UNITED STATES PATENT AND TRADEMARK OFFICE

APPLICATION NO.	FILING DATE	FIRST NAMED INVENTOR	ATTORNEY DOCKET NO.	CONFIRMATION NO.
10/676,245	09/30/2003	Erik L. Humble	MO03-P02	6384
7590	03/18/2005		EXAMINER	
John Reid Reidlaw LLC 1926 South Valleyview Lane Spokane, WA 99212			HESS, DOUGLAS A	
			ART UNIT	PAPER NUMBER
			3651

Office Action Summary	Application No.	Applicant(s)	
	10/676,245	HUMBLE ET AL.	
	Examiner	Art Unit	
	Douglas A Hess	3651

DETAILED ACTION

FIG. 1

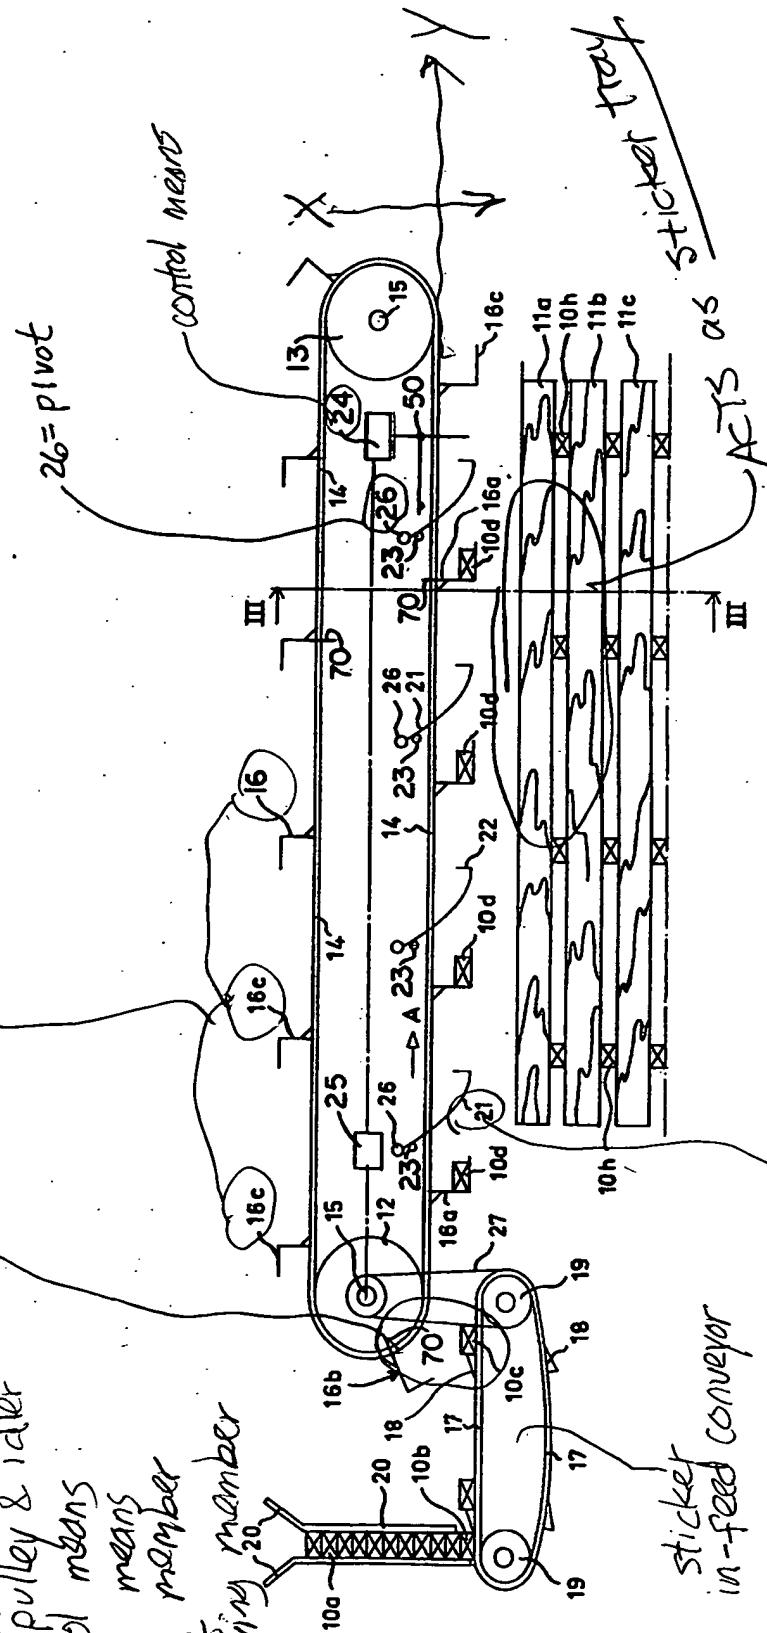
5. Claims 1 and 16-20 are rejected under 35 U.S.C. 102(b) as being anticipated by Rysti (US Pat. 4,144,976).

See the attached marked up copy of Rysti Drawing Figure 1 depicting the claimed features.

60 substantially no angular movement
@ pickup of sticker by bracket

60 = Sticker Support Bracket

1st Actuator
15+14 = conveyor moves supp bracket
with sticker in Y direction

2nd Actuator

21+23+26+24+25 moves sticker
in X-direction (drops down)

W.D.
H.D.
1st dimension

removing member-21=Overhead rate
